PUBLIC INTEREST REVIEW FOR GROUND WATER APPLICATIONS

SUBJECT: Application G- 17140 Supersedes review of N.A. (amendments occurred prior to review)
Date of Review(s)

A. GENERAL INFORMATION: Applicant's Name: Bandon Dunes Limited Partnership County: Coos

Transient Stream Depletion (Jenkins, 1970; Hunt, 1999, 2003)
COOS 54362 to Coquille River

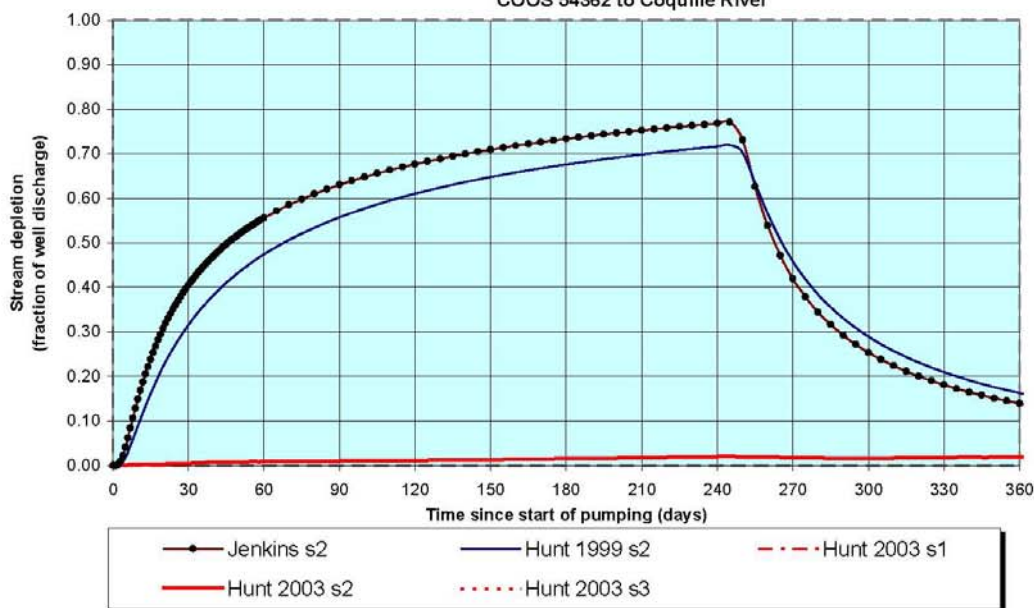
Proposed wells 1 and 2 (COOS 54362 and not drilled) are identified as hydraulically connected to the Coquille River located more than 1.00 miles from each well.

Interference at the river due to pumping each well at their proposed rates was calculated separately. Hunt (2003) was used given ground water at the proposed wells is currently identified as in a lower confined sand with gravel water bearing zone. The calculations used a transmissivity of 2700 ft²/day based on well COOS 54362 specific capacity, an assumed storage coefficient of 0.002, an assumed streambed thickness of 25 feet with a hydraulic conductivity of 0.135 ft/day (1/100 of the aquifer hydraulic conductivity). The interference values should be considered high given each calculation assumes the interference is with the river only. In reality, the interference is likely distributed to both the river and the Pacific Ocean making the actual interference smaller than calculated.
